RE: IESI – Bethlehem Landfill
Response to EAP Letter Dated 9/27/16
Our file: b/1162.3/2016/EAP/RL92716

We are in receipt of your September 27, 2016 2nd EAP review letter and are providing responses as follows. We have included the DEP comments in conventional font, with our responses in **bold text**.

Southeastern Realignment - Cap Removal & Waste Relocation Plan and Procedures

FIGURE 1 – Lower Saucon Township

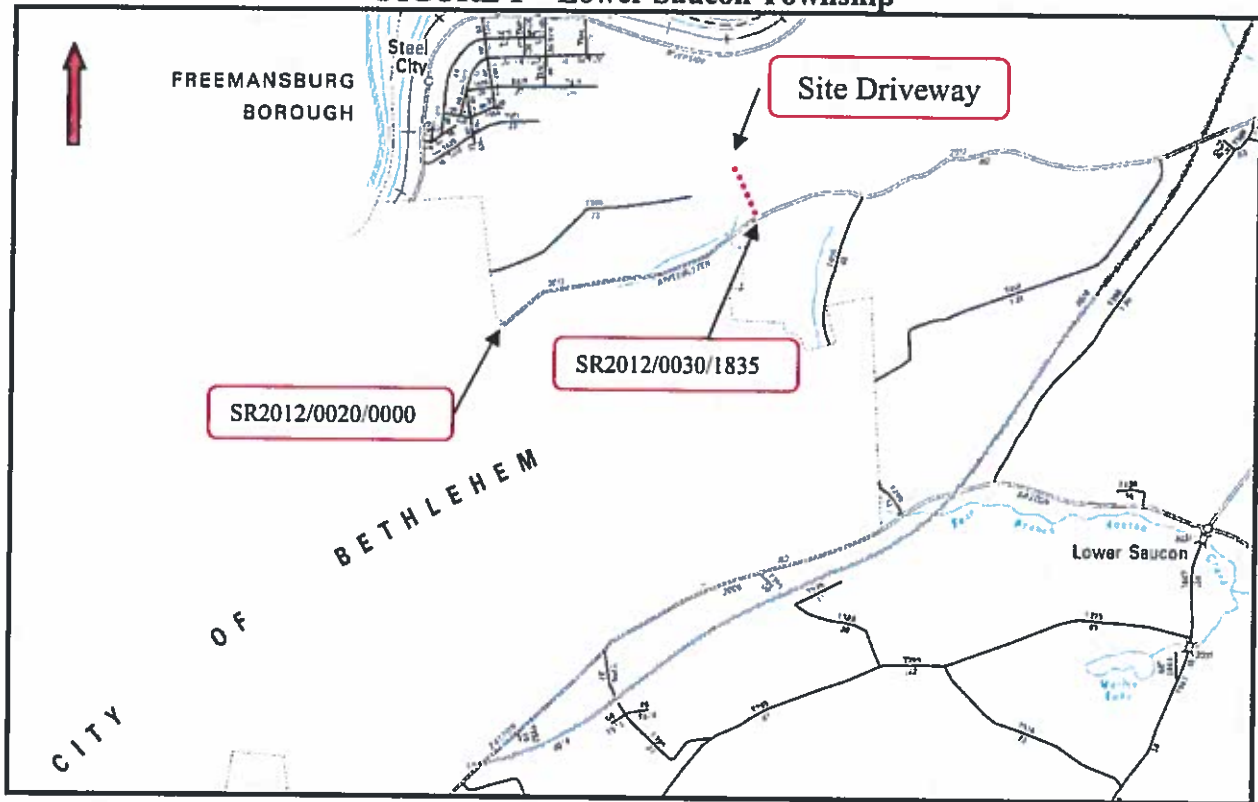
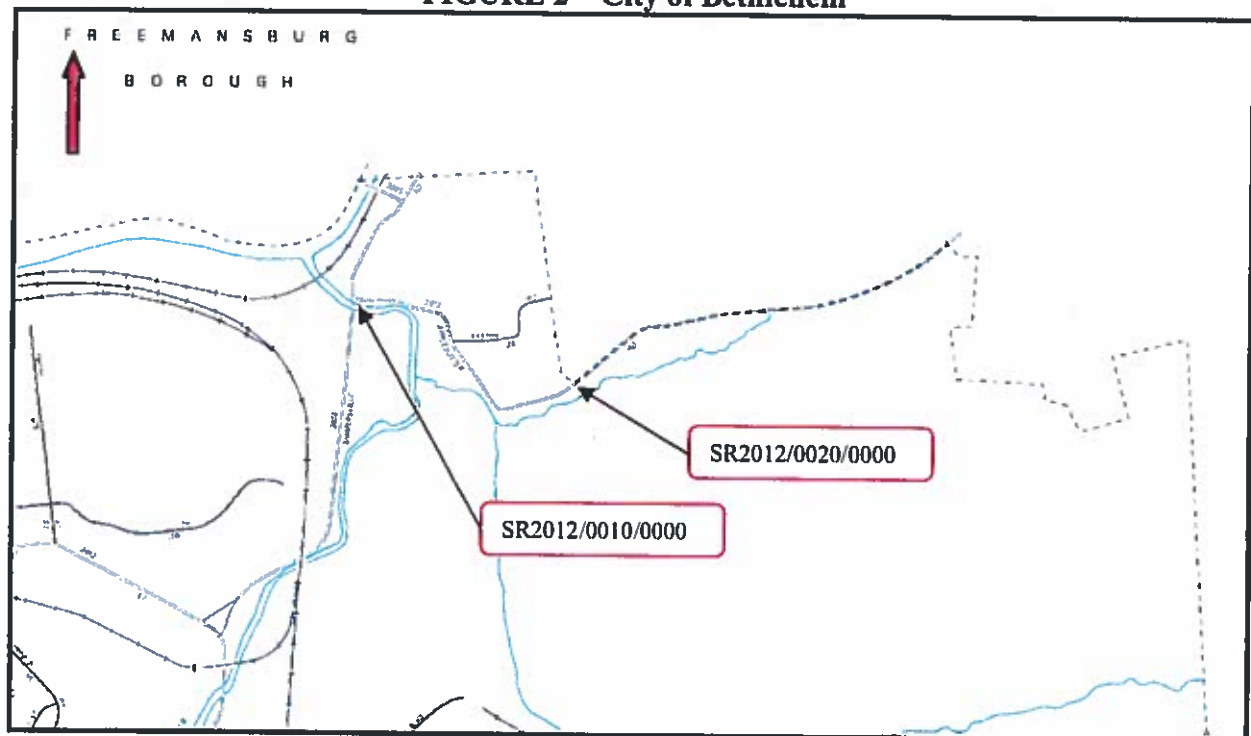
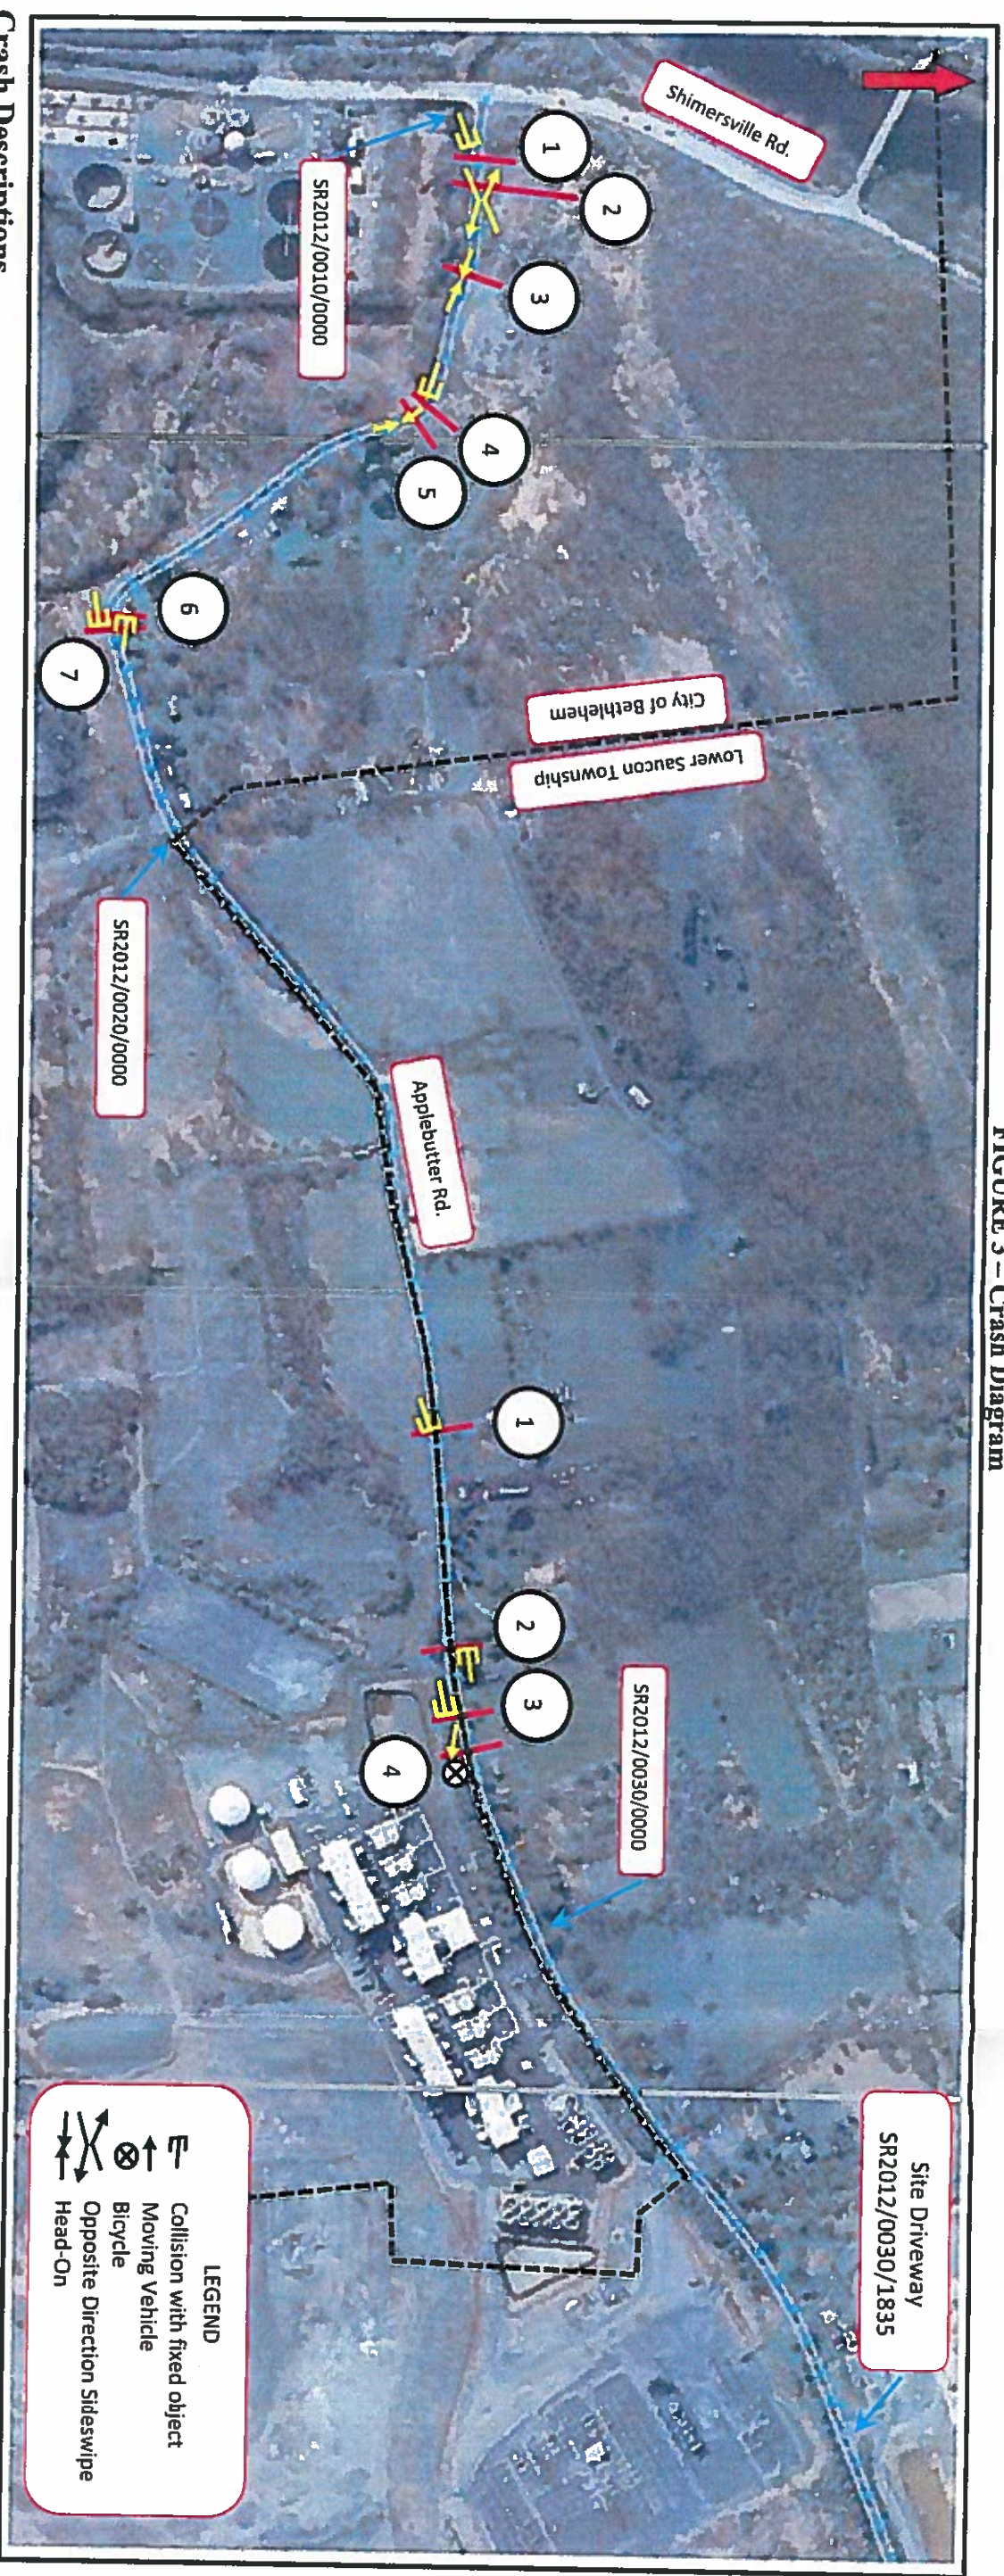
While the calculated crash rates along Applebutter Road (SR 2012), Segments 0020 & 0030, are higher than the state wide average rates for similar roadways as noted above, the number of crashes are low and are not associated with Landfill traffic. No crashes were found at the intersection of Applebutter Road (SR 2012) and the Site Driveway.

Accordingly, a roadway signage evaluation was performed along Segments 0010, 0020, and 0030 of Applebutter Road (SR 2012) to assess existing warning sign conditions and offer suggestions on improving safety.
